Rezoning Transportation Analysis

Petition Number: 2017-077

General Location Identifier: 067-045-16

Date	Description
05-17-17	First Review

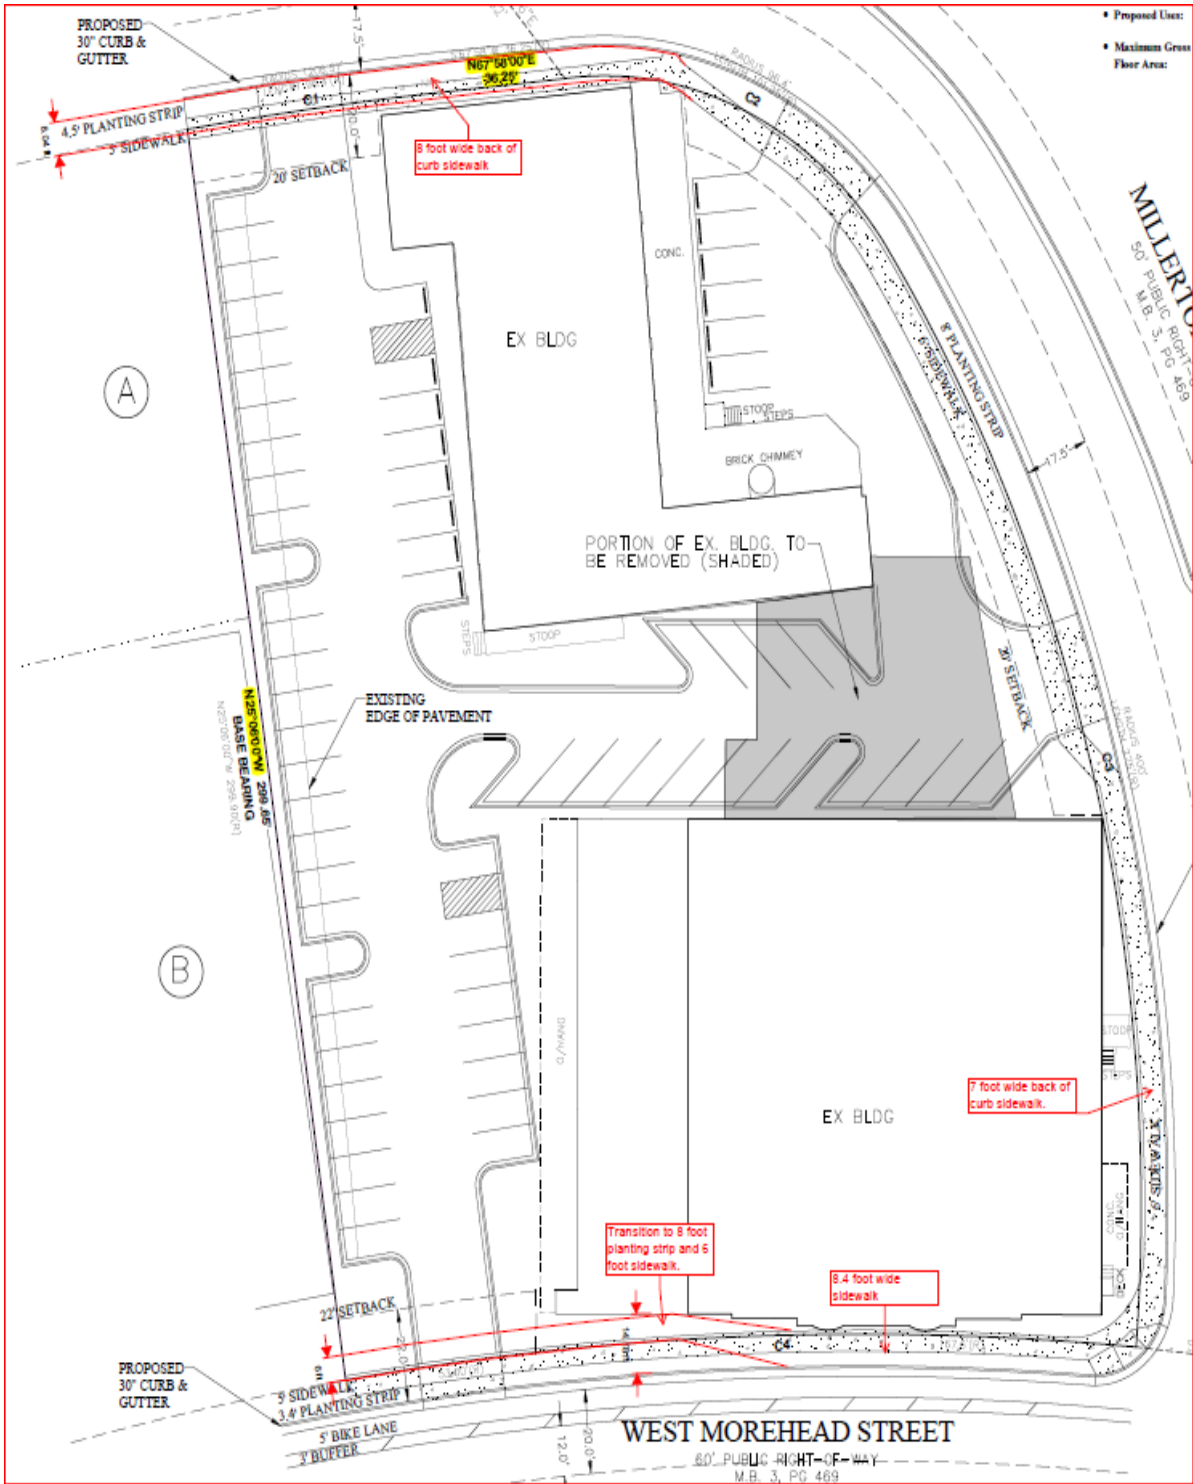
- Curbline** The proposed zoning district has a setback measured from back of the existing or proposed future curbline. The location of the future back of curb is 17.5 feet from the center of Millerton and is accurately shown on the plan. The existing back of curb is in the future location on Morehead.
- Traffic Study** A Traffic Impact Study/Transportation Technical Memorandum is not needed for the complete review of this petition.
- The petitioner should revise the site plan to show standard 8' planting strip and 6' sidewalk along as much of the site's public street frontage as possible (i.e. add along eastern portion of Morehead frontage) and 8' back of curb sidewalk in areas where existing buildings do not allow the standard section. Additional pinch points (but no less than 7' back of curb sidewalk) can be detailed during

permitting. Petitioner should also consider planting strip behind sidewalk along areas where back of curb sidewalk is needed. Use sketch below as a guide.
